MEIC's Analysis of NorthWestern Energy's 2026 IRP

Utility Solar O&M Cost Escalations Under Different Methodologies

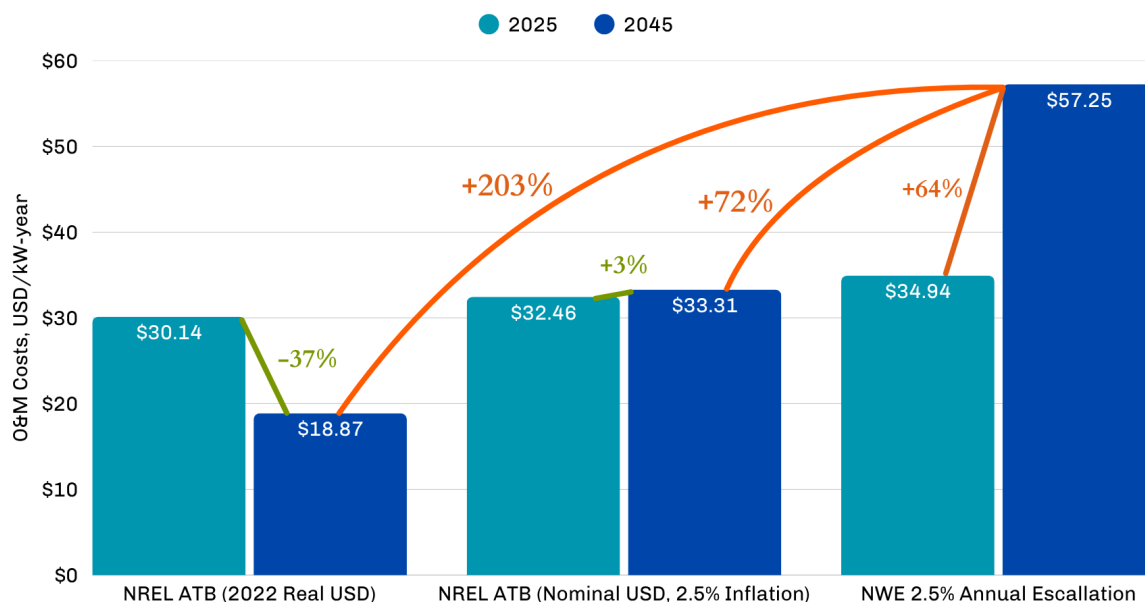
A closer look at NREL’s projections show that renewables’ O&M costs are decreasing drastically in *real* dollars from 2025 to 2045: A 43% decrease for solar and 37% decrease for wind. Using a 2.5% annual inflation rate for year-to-year *nominal* dollar costs still shows an overall 6% decrease to solar O&M through the planning horizon, and only a marginal 3% increase to land-based wind O&M. In comparison, assuming a fixed 2.5% annual increase to O&M costs creates completely unrealistic and misleading price projections. Compared to NREL’s projection of a 43% *real* dollar *decrease* to solar O&M between 2025 and 2045, a fixed 2.5% escalation leads to a 64% *increase* over that same horizon. This misguided escalation assumption projects solar O&M costs in 2045 that are between 101% and 254% higher than

Utility Wind O&M Cost Escalations Under Different Methodologies

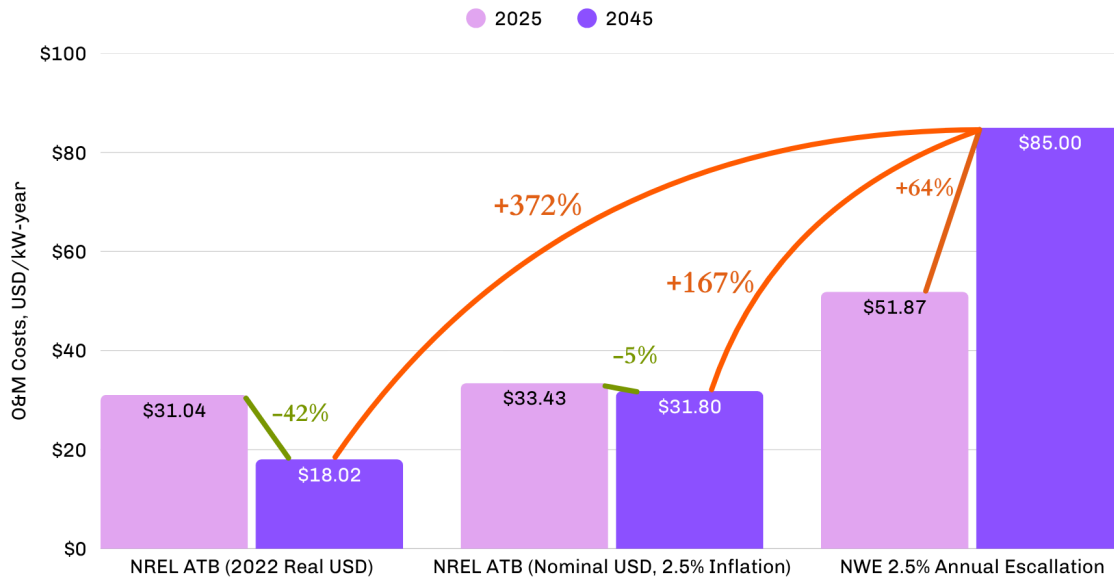
NREL's projections. And compared to NREL's projection of a 37% *real* dollar decrease to land-based wind O&M between 2025 and 2045, a fixed 2.5% escalation again leads to a 64% *increase* over that same horizon. This projects wind O&M costs in 2045 that are 72% to 203% higher than NREL's projections. The same can be said for 4-hour battery O&M costs, where NREL projects a 42% *real* and 5% *nominal* decrease to O&M costs from 2025 to 2045. Yet, using a fixed 2.5% fixed annual increase results in a 64% increase over the planning horizon, resulting in O&M costs in 2045 that are 167% to 372% higher than NREL's projections.

4-Hr Battery O&M Cost Escalations Under Different Methodologies

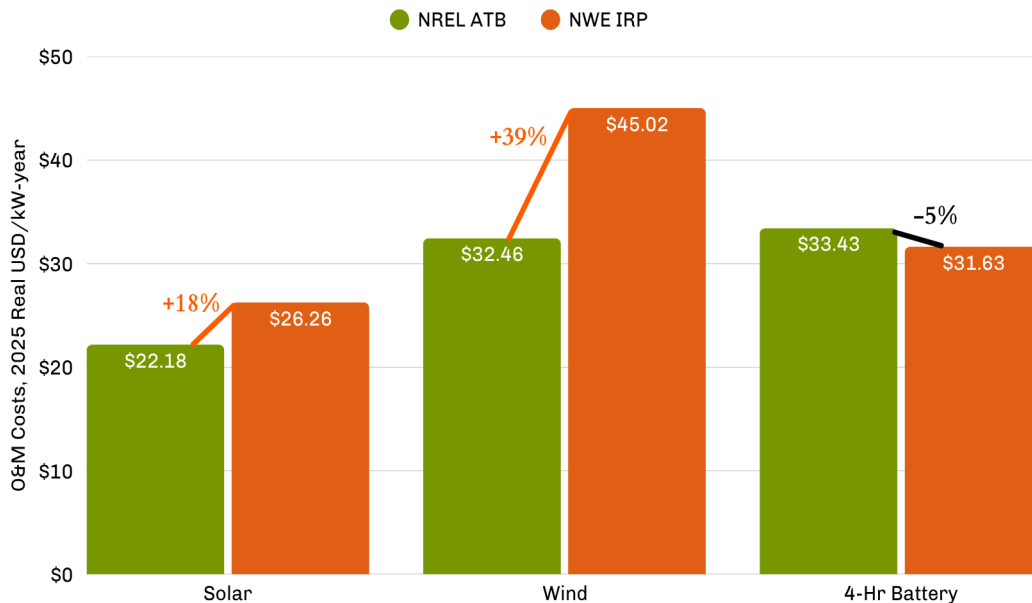
Not only are the O&M *escalations* for wind, solar, and storage completely off from standard assumptions, but initial O&M cost assumptions used for wind and solar in this IRP for costs in 2025 (IRP Table 35) start off already drastically higher than costs outlined in NREL's 2024 ATB. While the IRP shows fixed O&M costs for solar of \$26.26/kW-year in 2025, that is 18% higher than NREL's estimate (adjusted to *real* 2025 dollars) of \$22.18/kW-year. The IRP shows fixed O&M costs for wind of \$45.02/kW-year in 2025, which is 39% higher than NREL's \$32.46/kW-year. The starting point fixed O&M costs for 4-hour battery storage used in the IRP are closer to NREL's projections.

NREL ATB vs. NWE Starting O&M Costs for Solar, Wind, & 4-Hr Battery

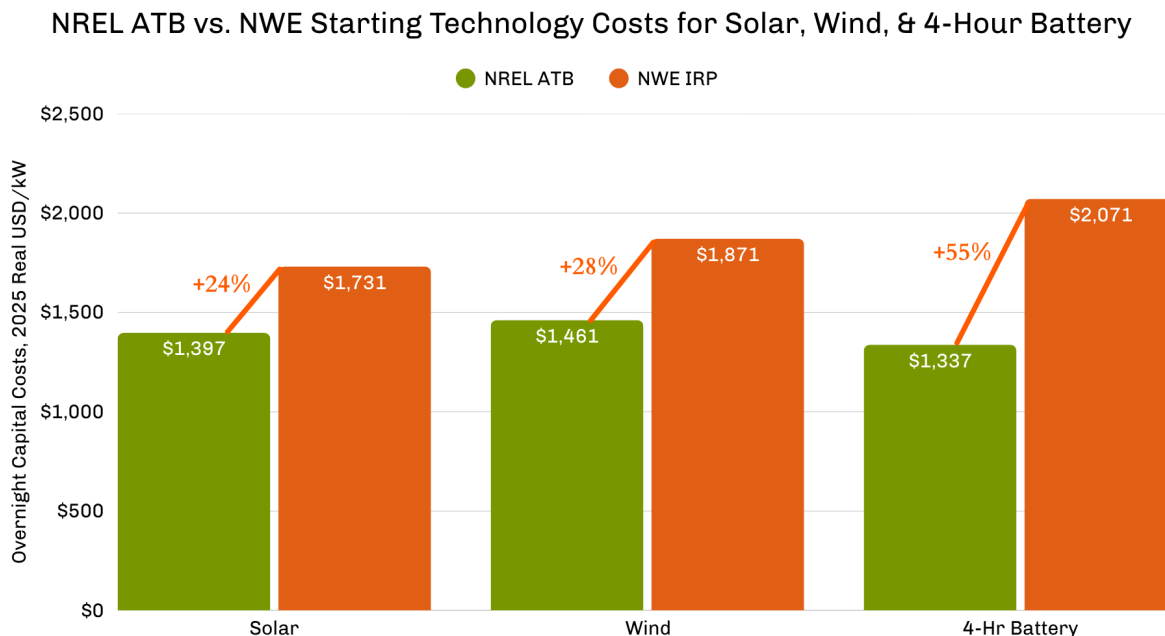
So while O&M costs continue to plummet for wind, solar, and storage, the IRP assumes the exact opposite, artificially escalating costs throughout the planning period. Furthermore, O&M costs of resources in NorthWestern’s portfolio beyond 2045 appear to not be captured in the 20-year net present value (NPV) nor the remaining book life charts. Given that the O&M costs of coal, gas, and nuclear infrastructure continue to escalate, while wind, solar, and storage costs continue to fall, this is another benefit of a clean portfolio that is not captured in the IRP.

TABLE 25: 2024 HISTORICAL EMISSIONS.

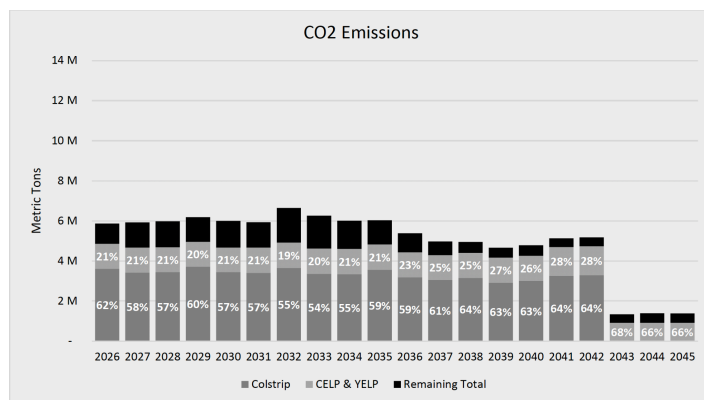
lays out 2024 CO2 emissions for existing thermal resources, includes emissions rates for SO2, NOx, and CO2 for the various gas candidate resources considered (Table 34), and graphs CO2 emissions for each contemplated portfolio. Unfortunately, the emissions rates provided are unhelpful in determining the total emissions of a given candidate thermal resource because they are provided as lbs/MMBtu, and cannot be converted to total plant emissions (or lbs/MWh) without additional information on the heat rate for each candidate resource. Despite the IRP's heavy reliance on gas generation, fueled predominantly by methane, the IRP fails to mention methane emissions associated with leaks in methane extraction, processing, storage, and transmission, nor does it discuss methane's potency as a greenhouse gas with [86 times](#) the climate warming potential per unit of mass compared to CO2 over a 20-year period.
